## Proposal for 11 series of amendments to UN Regulation No. 17 (Strength of seats)

### Submitted by the Working Party on Passive Safety \*

The text reproduced below was adopted by the Working Party on Passive Safety (GRSP) at its seventy-third session (ECE/TRANS/WP.29/GRSP/73 para. 21). It is based on ECE/TRANS/WP.29/GRSP/2023/5 as amended by annex IV to the report. It is submitted to the World Forum for Harmonization of Vehicle Regulations (WP.29) and to the Administrative Committee (AC.1) for consideration at their November 2023 sessions

Model A

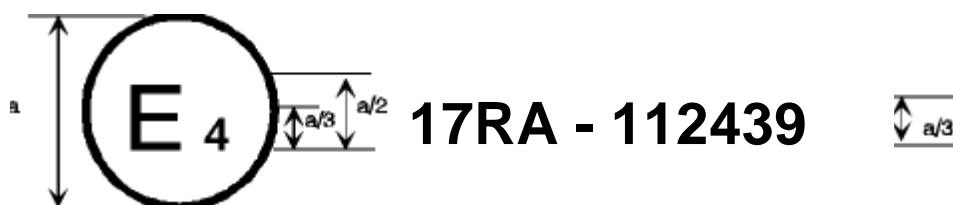
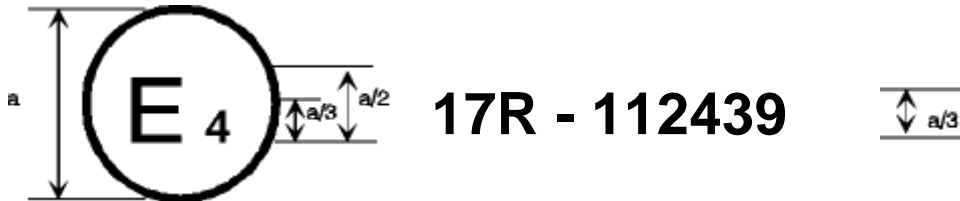
*Annex 2, amend to read:*

Vehicle with at least one seat fitted or capable of being fitted with a head restraint

The above approval mark when affixed to a vehicle shows that the vehicle type concerned, with regard to the strength of the seats fitted or capable of being fitted with head restraints and with regard to characteristics of the head restraints, has been approved in the

Netherlands (E 4) pursuant to UN Regulation No. 17, under the approval number 112439. The first two digits of the approval number indicate that the Regulation already contained the 11 series of amendments at the time of approval. The above approval mark also shows that the vehicle type was approved pursuant to UN Regulation No. 17 with regard to the strength of any seats on the vehicle which are not fitted or capable of being fitted with head restraints.

Model C

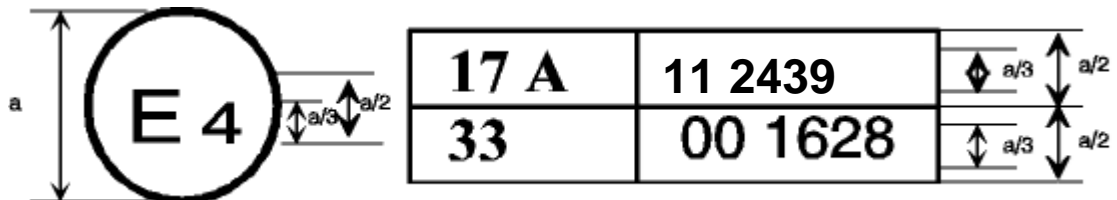
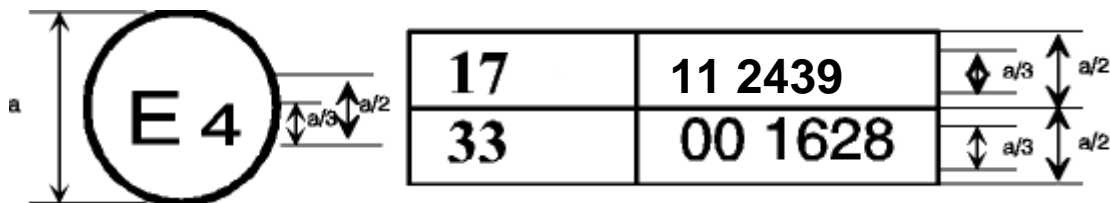
Vehicle with at least one seat fitted or capable of being fitted with a head restraint

The above approval mark when affixed to a vehicle shows that the vehicle type has at least one seat fitted or capable of being fitted with a head restraint, and was approved in the Netherlands (E 4) pursuant to UN Regulations Nos. 17 and 33.<sup>1</sup>

The approval numbers indicate that, on the dates when approval was granted, UN Regulation No. 17 included the 11 series of amendments, but UN Regulation No. 33 was still in its original form. The above approval mark also shows that the vehicle type was approved pursuant to UN Regulation No. 17 with regard to the strength of any seats on the vehicle which are not fitted or capable of being fitted with head restraints.
